RE: Response to Department Technical Deficiency Letter Quaker Valley School District
NPDES Permit Application No. PAD020098
Leet Township, Leetsdale & Edgeworth Boroughs, Allegheny County

Phillips & Associates, Inc., Streamline Engineering, Inc., and Civil & Environmental Consultants, Inc. have reviewed the Technical Deficiency Letter dated December 24, 2025. Below are the responses:

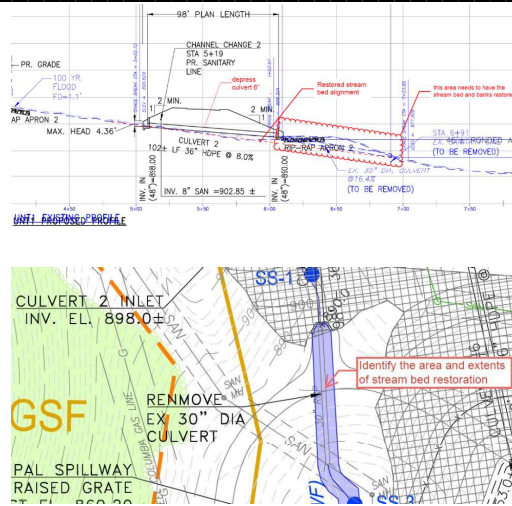
8. §102.4(b)(5)(ix), §102.8(f)(9): What do the two bold dashed lines represent at the interior base of the sediment basin SB-1/MRC stormwater basin SB-1. Please revise and/or explain.

The previously submitted PCSM104A "PCSM Plan Sheet 1 of 4," the dashed lines indicate the bottom and top contour surfaces of the soil media in the proposed MRC pond. The location and design have changed for the two proposed SWMF. (See new design drawings and design calculations in NPDES Module 2).

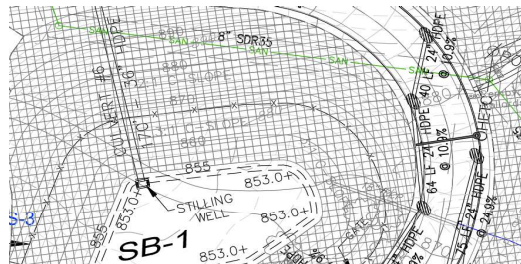
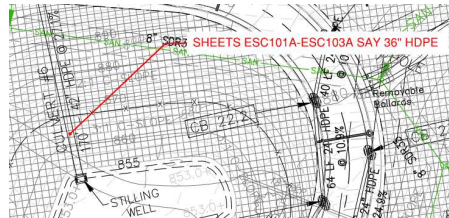
12. §102.4(b)(5)(ix), §102.8(f)(9): The CADD drawing quality provided on each sheet of both the E&S and PCSM plans, including the drainage area mapping within the reports is incredibly cluttered, and messy.

The drawings are littered with overlapping text, mix-matched font sizes styles, and excessive use of callouts at various angles, making the drawings difficult to read. Items proposed for demolition early within the E&S construction phases are still depicted within the later E&S and PCSM phases. Please revise.

The E&S and PCSM drawings have been revised to improve clarity of the information presented. (See new design drawings in E & S Module 1 and NPDES Module 2).

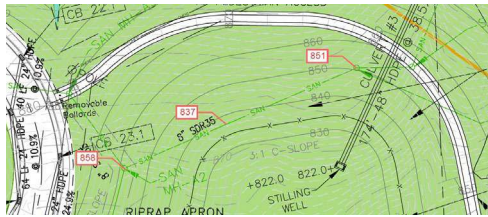
18. §102.4(b)(5)(ix), §102.8(f)(9): The stilling well detail on sheet PCSM300 indicates a 12-ft wide R-5 Rip-Rap [PS13.1] apron is to be placed around the stilling well inlet box. The plan view drawings neither

mention nor indicate an apron to be placed around the stilling well of either basin. Please depict this apron to scale on the plan drawings.

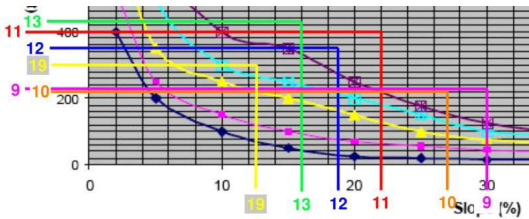
32. §102.4(b)(5)(viii), §102.4(b)(5)(ix): Nearly every proposed compost filter sock is shown crossing multiple contours. Please review each proposed CFS sediment barrier and adjust each sock so that is shown on grade, with proper up-turns to avoid forming low points or diverting concentrated flow.

The locations of the proposed compost filter socks have been revised to follow along the existing contour. (See new design drawings and calculations in E & S Module 1 and NPDES Module 2).

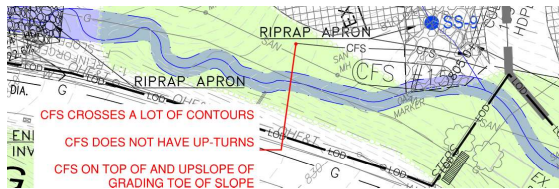
appears to exceed the slopes/lengths for 32-inch for socks 9-13 and 24-inch sock 19. Consider the use of a sediment trap or other BMP with appropriate capacity for use within the watershed of socks 9-13. Review all CFS sizing and ensure that the maximum slope lengths are used for sizing in all areas. Update the drawings and provide revised supporting calculations.

We have labeled all the proposed compost filter socks by stage and shown the flow path on the Stage E & S Plans. We also have included spreadsheets that calculate the flow path slopes, size of sock and sock slope length capacity for each CFS flow section. (See new design drawings and calculations in E & S Module 1).

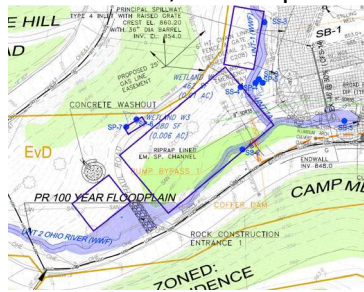
152. §102.4(b)(5)(ix): Phase 1: Additional perimeter CFS is needed below Basin 2 grading in this area:

With the change of the watershed to HQ designation the previous two sediment basins have been replaced with proposed sediment basin SB-1 which is located further away from UNT-2. Due to the existing channelized topography below SB-1, existing UNT-6, a rock filter will be installed in UNT-6 to filter runoff from the construction of SB-1, outlet pipes and rip-rap apron. (See new design drawings and calculations in E & S Module 1).

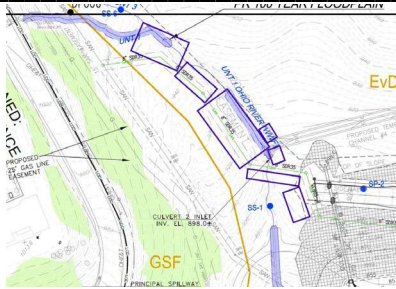
153. §102.4(b)(5)(ix): Phase 1: Additional CFS is needed between the haul road from RCE #1 to SB-1, including below the proposed concrete washout in this area. No protection is provided for wetland W3 or for UNT 2, and no protection is provided for UNT 1 or 1A or wetland W2.

Compost filter sock (CFS) has been added below the haul road from RCE #1 to SB-1 and around the proposed concrete washout in this area on the plans. Protection fencing has also been added around wetlands W1, W2 and W3. (See new design drawings and calculations in E & S Module 1).
